YEAR 5 (2019) MONITORING REPORT
ABBEY LAMM
STREAM AND WETLAND MITIGATION SITE
ALAMANCE COUNTY, NORTH CAROLINA
FULL DELIVERY CONTRACT No. 5790
DMS PROJECT No. 96311
NCDWR PROJECT No. 20140336
USACE ACTION ID No. SAW-2014-01710

Subject: Draft Monitoring Year 5 Annual Monitoring Report
Abbey Lamm Stream and Wetland Mitigation Site (DMS #96311)
Cape Fear River Basin 03030002, Alamance County
Contract No. 005790

Below is the response from Restoration Systems to all comments received on the Draft Abbey Lamm Yr. 5 (2019) monitoring report. DMS comments are in black, and our responses are in blue. Please do not hesitate to reach out if you would like to discuss.

Figure 2. Current Conditions Plan View (CCPV)

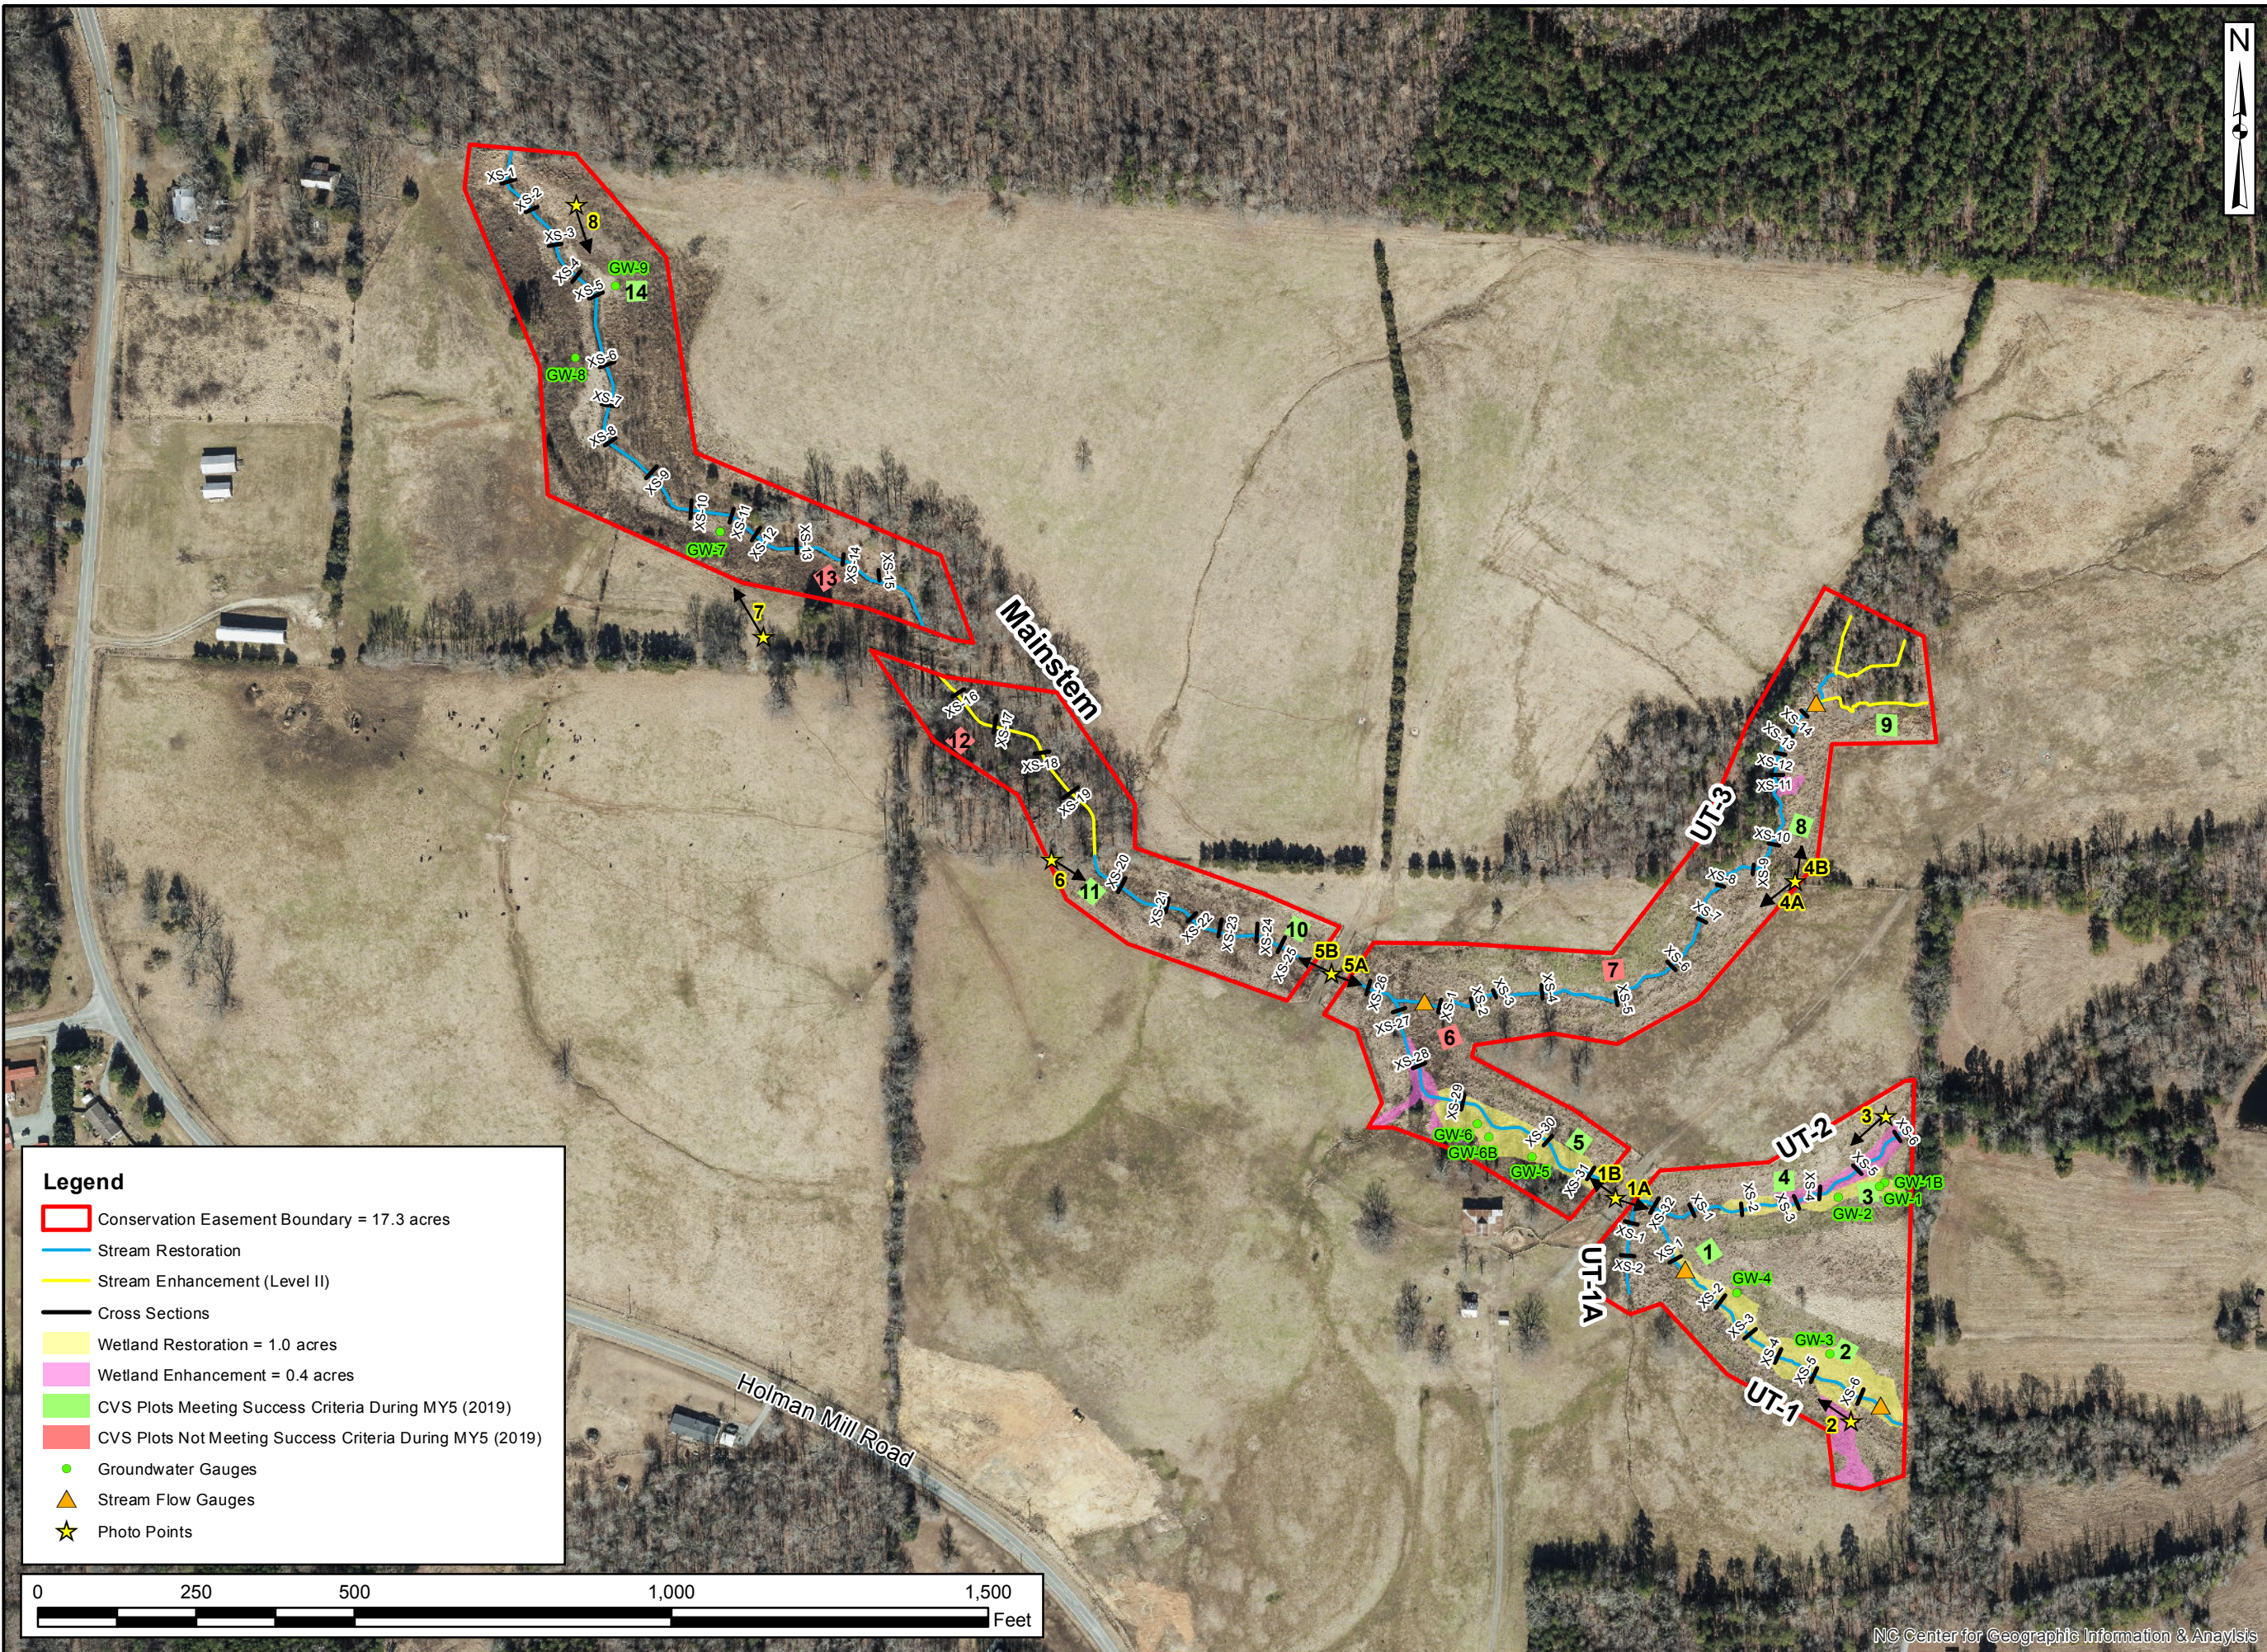
5. Appendix B
 - a. Figure 2 – Please update the CCPV to differentiate between Restoration and Enhancement reaches.
Figure 2 was updated to differentiate between stream restoration and enhancement reaches.

Site	Abbey Lamm
Watershed:	Cape Fear, 0303002
XS ID	Main Channel XS - 9, Riffle
Feature	Riffle
Date:	3/4/2019
Field Crew:	Perkinson, Radecki

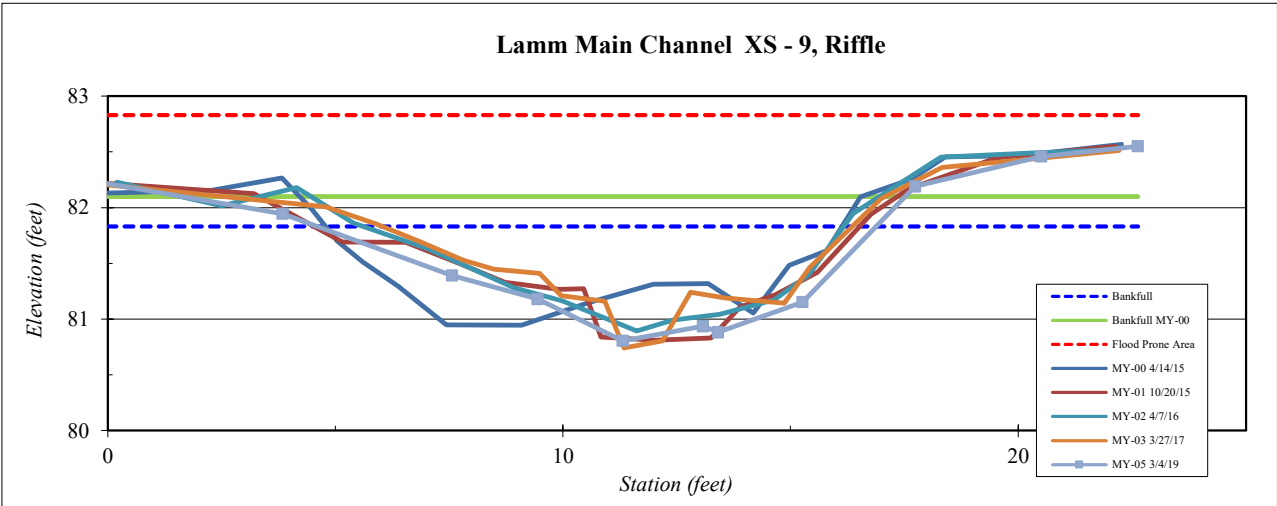
- b. On cross section 9 (and elsewhere) there is a footnote that reads “Elevated BHR results from shallow channel depth.” Please explain in more detail what is meant by this.
The footnote was changed to the following in order to clarify: “No problems have been noted in this reach. Minor alterations in shallow channels may result in large discrepancies including elevated BHR.”

Lamm Groundwater Gauge 6 Year 5 (2019 Data)

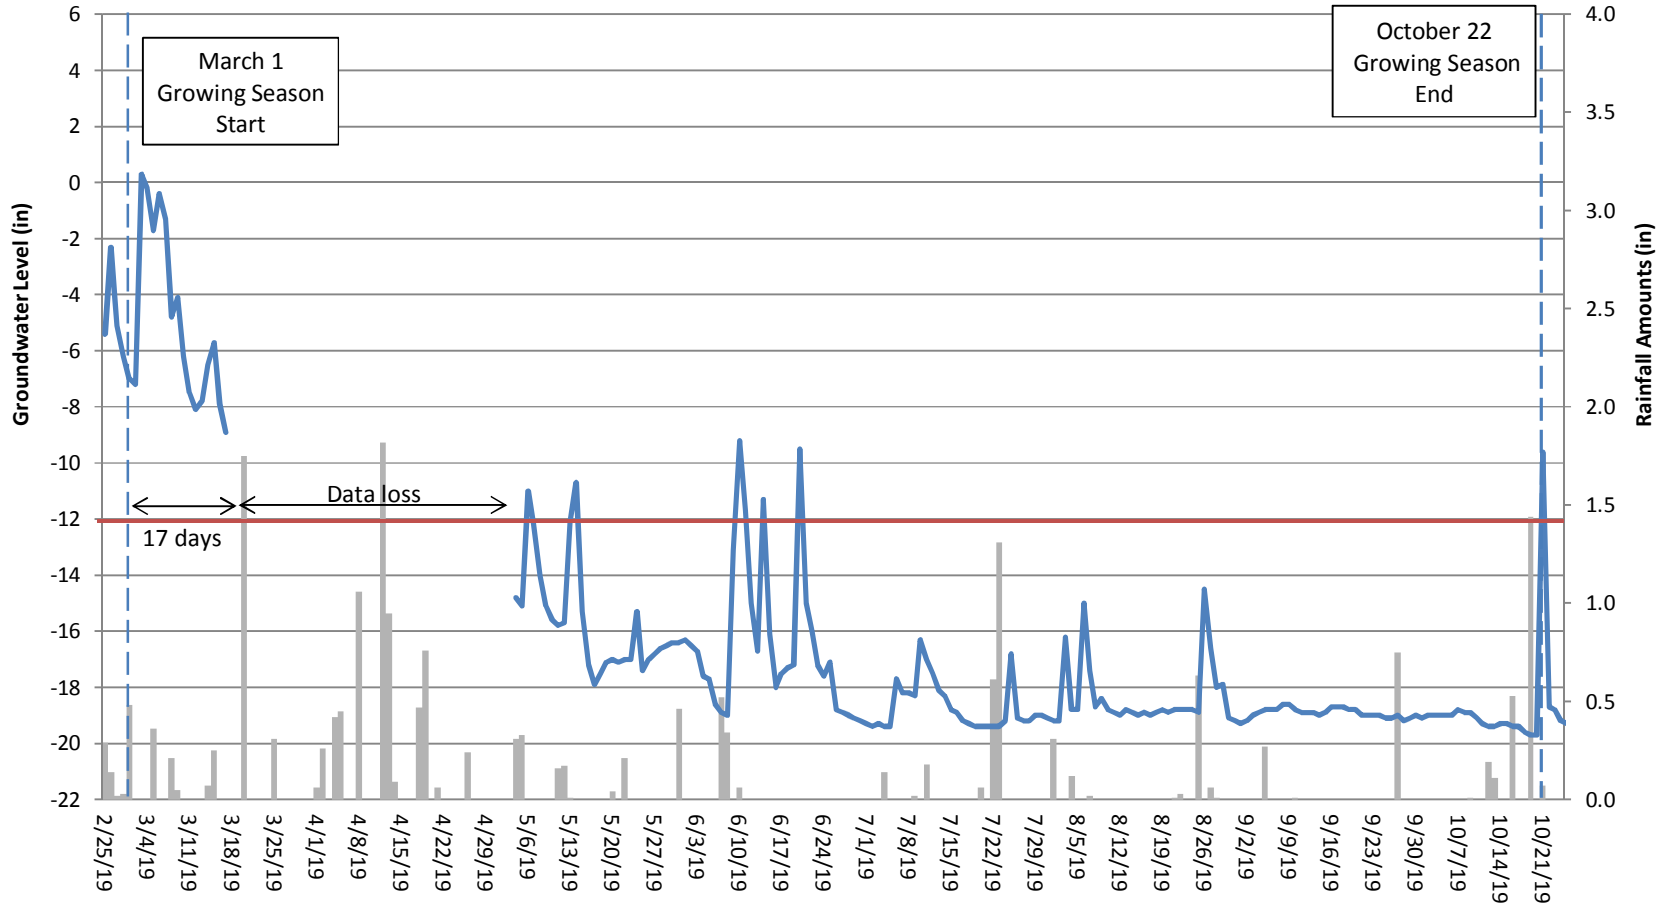
- a. Wetland Hydrology Gauge Table – Please shade the text red for gauge 6.

- b. The footnote below the Hydrology Gauge Table that states “# These gauges did not meet success criteria due to a data shuttle failure that resulted in the loss of data...” Please be more specific about what data was lost.

7. Appendix E
 - a. Table 14 – See comment 2. Please shade the gauge that did not meet red, and elaborate on the footnote regarding data loss.
Gauge 6 was shaded red, and the footnote was revised as above to include “...from March 20 to May 3.”

Text for gauge 6 was shaded red.

The statement was revised to read: “These gauges did not meet success criteria due to a data shuttle failure that resulted in the loss of data from March 20 to May 3. Based on rainfall and hydrology data that was not lost, these gauges would have likely met success criteria had the loss of data not occurred.”
